76 Fitzjohn's Avenue
London
NW3 5LS

Basement Impact Assessment

For
London Borough of Camden

Project Number: 12466-62
Revision: F2

Appendix 3 – Drawing to illustrate impermeable area.

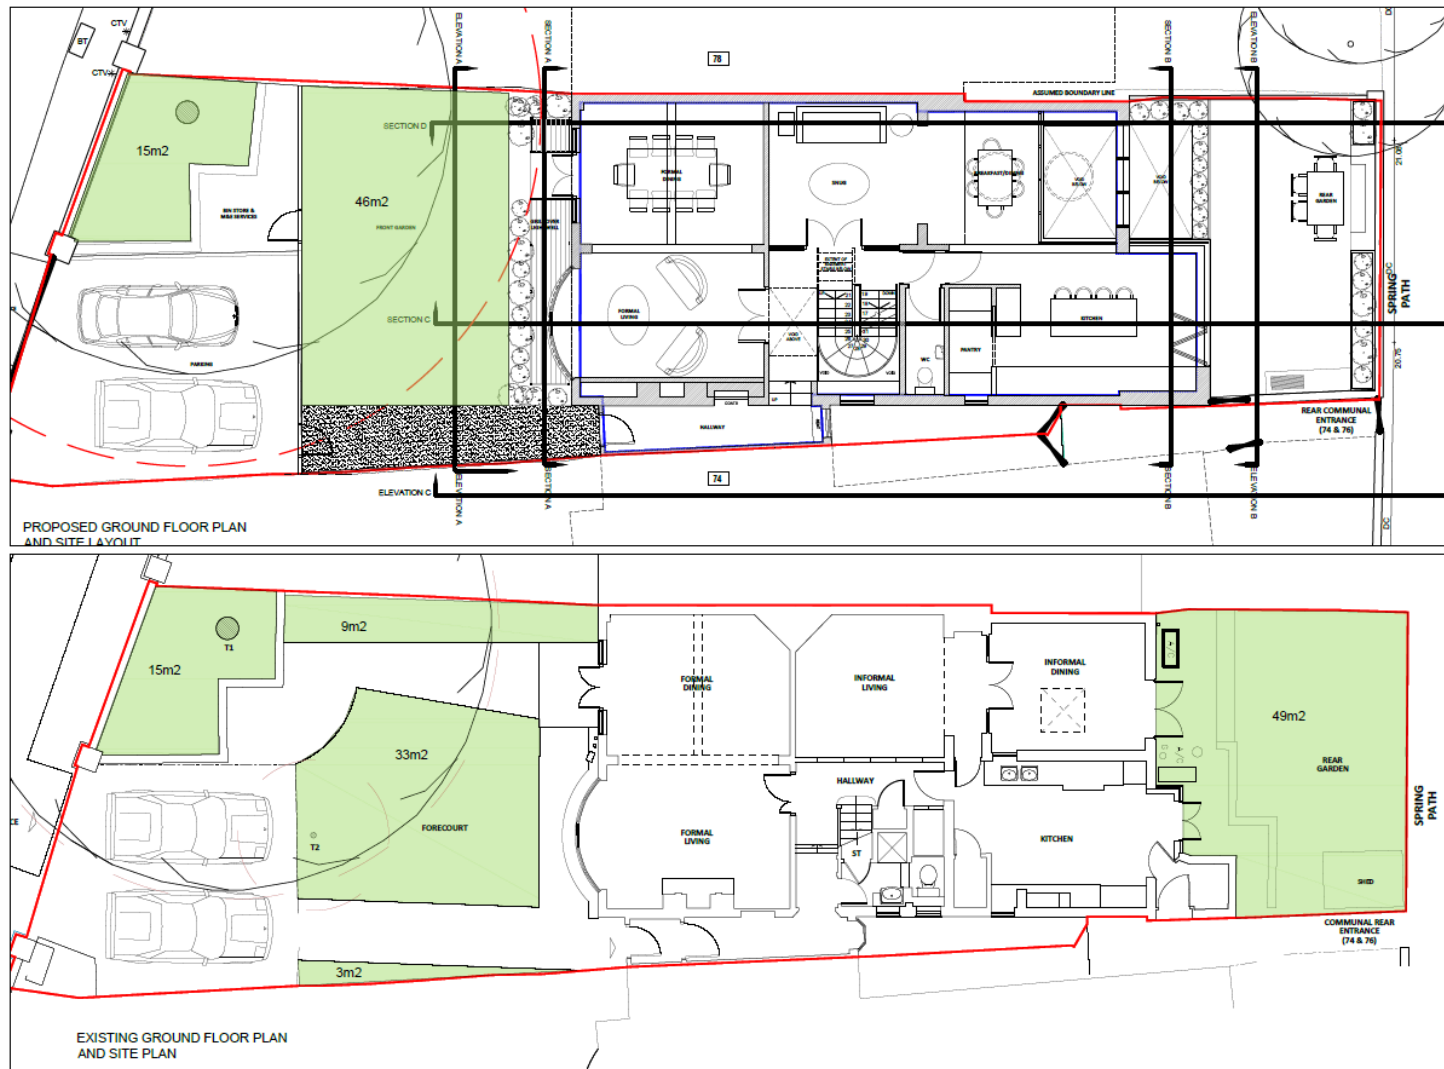
12	Evidence that the area of impermeable area is not increasing is required, given that the lightwells are impermeable. Details of SUDs are required should the impermeable area be increasing.	The amount of impermeable area is increasing by 1sqm. A drawing illustrating this is included in Appendix 3.
